**RIO RANCHO PUBLIC SCHOOLS
PROCUREMENT DEPARTMENT**

ADDENDA #4

RFP No. 2018-010-IT

Project: Purchase Category 2 E-Rate

RRPS
ESES

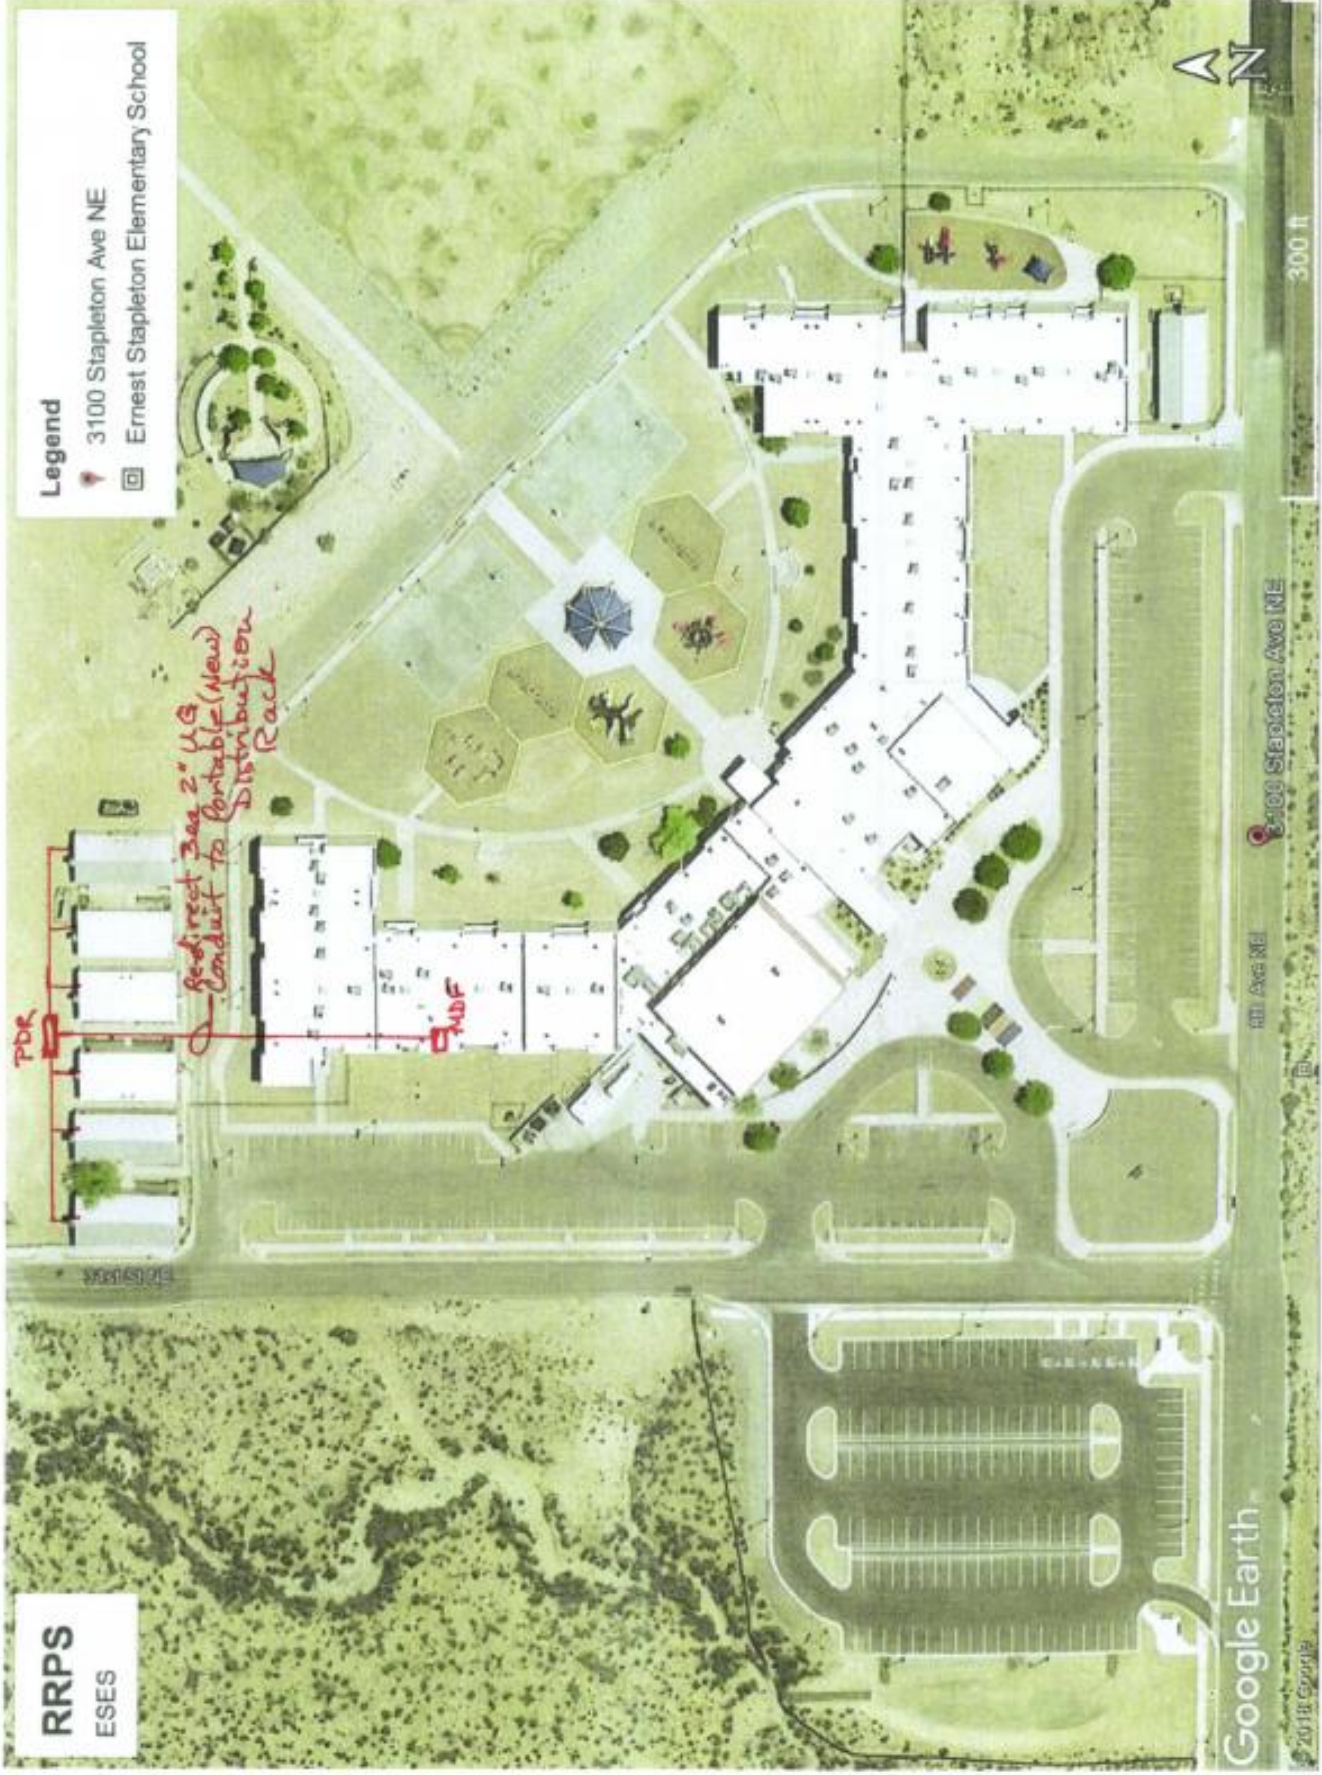
*Redirect 3000 2" U.S.
Conduit to Portable (New)
Distribution
Rack*

RRPS
ERMS

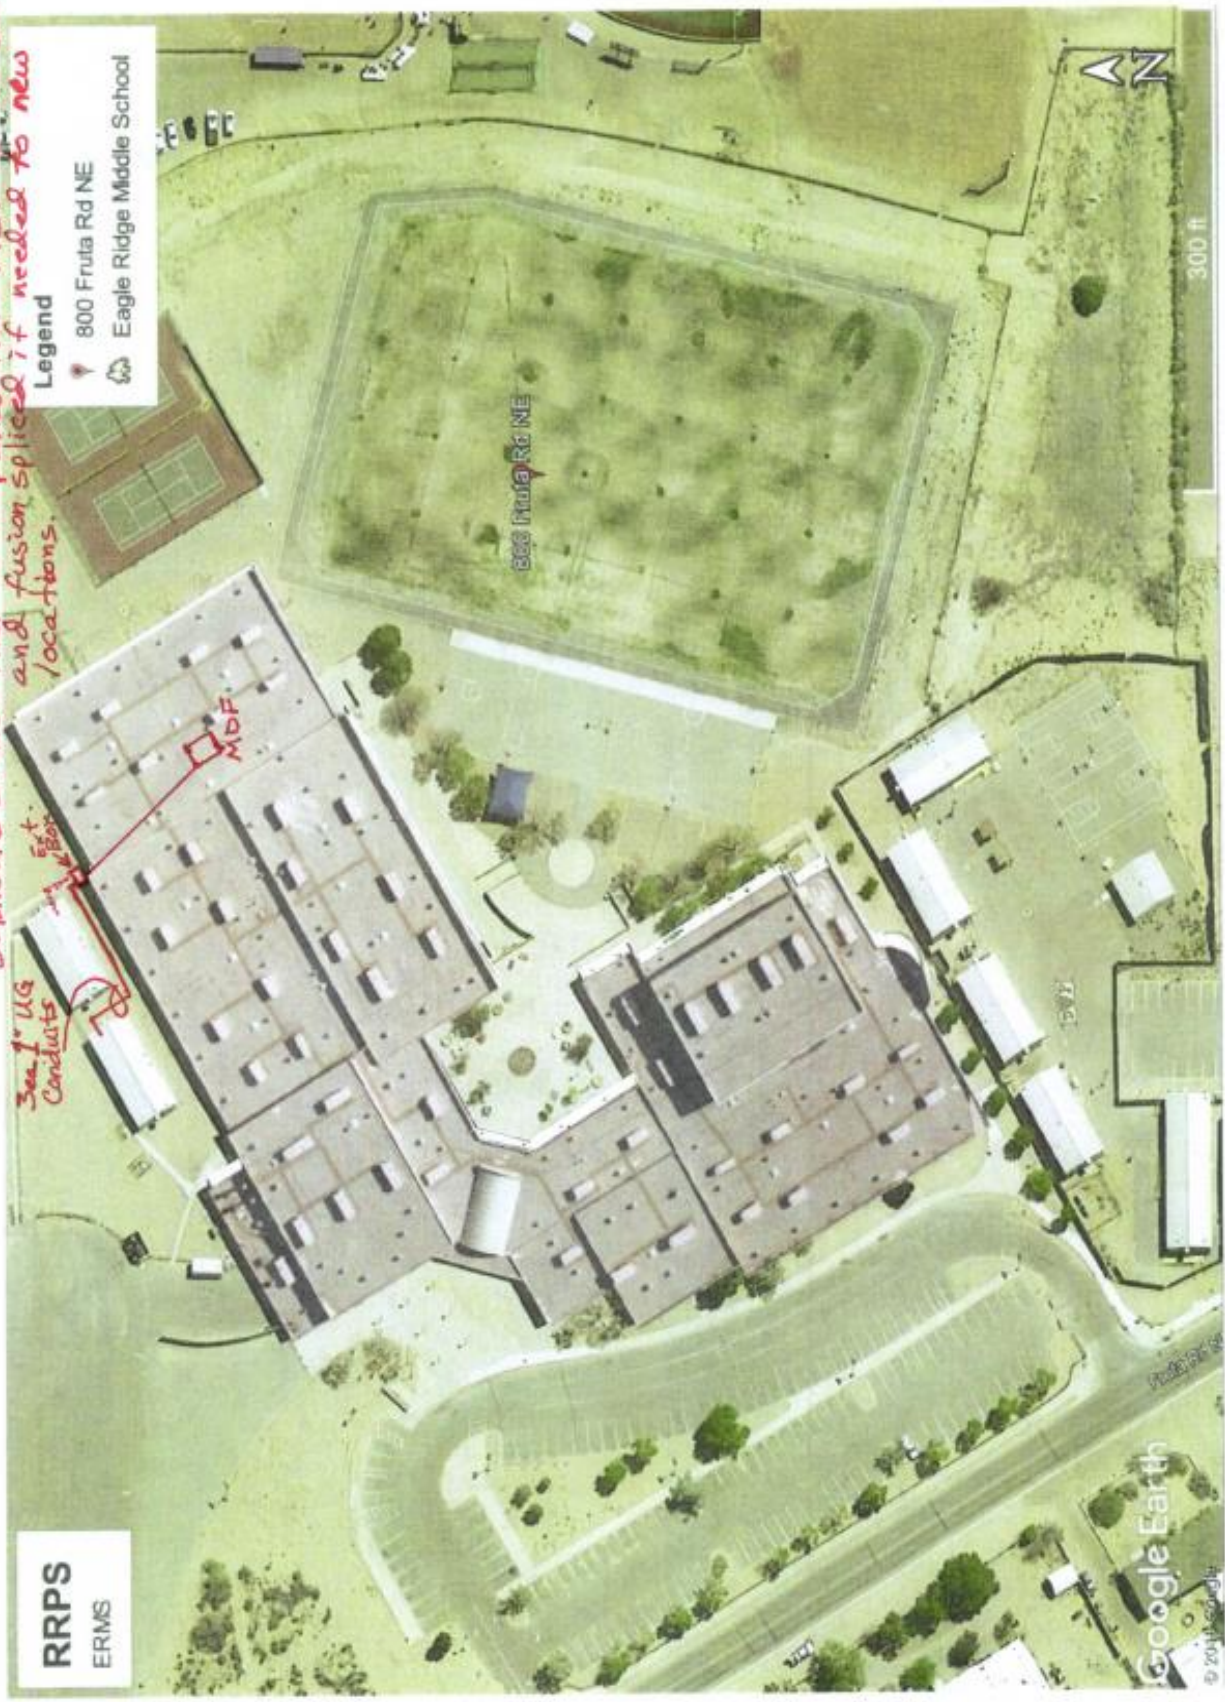
50 micron 6 strand fiber to be pulled from MDF to Ext. Box and fusion spliced if needed to new locations.

See 1/18 Conduits
